Docket Item #18
BAR CASE #2005-0099

BAR Meeting
May 18, 2005

ISSUE: Addition
APPLICANT: Nancy Doody
LOCATION: 315 South Columbus Street
ZONE: RM/Residential

Figure 2 North elevation

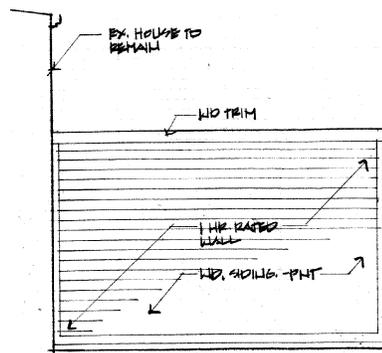
Staff believes the proposed addition is appropriate for the house and neighborhood. The one story addition is modest in size. Although it will extend approximately 16' beyond the rear elevations of the houses on either side, it will not overwhelm these properties. It is only 11' high at its highest point on the north side and is well removed from the structure to the north, which has a side yard. On the south side, it is only 8'9" high and is held back 3' from the south property line.

Figure 3 South elevation

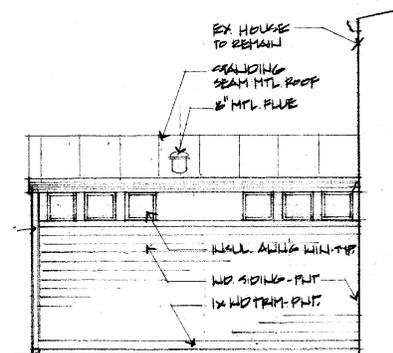
1. That the south wall be pulled back from the property line several more inches to ensure that the windows will still meet code in the event of construction error in the placement of the north wall; and,
2. That the statement below appear in the General Notes of the site plan so that on-site contractors are aware of the requirement:

The proposed addition is traditional in form and materials. The band of windows on the south elevation is a more modern design element, but one which Staff believes is compatible. With regard to these windows, Building Code prohibits openings in exterior walls within 3' of an interior lot line. The proposed windows are at 3' exactly. Therefore, Staff recommends that the south wall be pulled back from the property line several more inches to ensure that the windows will still meet code in the event of construction error in the placement of the north wall. Staff notes that the *Design Guidelines* recommend the use of true divided light windows, but do allow the use of simulated divided light windows where the windows are not readily accessible to the public. Their use in the proposed addition will meet that criteria. Lastly, Staff notes the comments of Alexandria Archeology and recommends that they be included as a condition of the approval.

1. That the south wall be pulled back from the property line several more inches to ensure that the windows will still meet code in the event of construction error in the placement of the north wall; and,
2. That the statement below appear in the General Notes of the site plan so that on-site contractors are aware of the requirement:
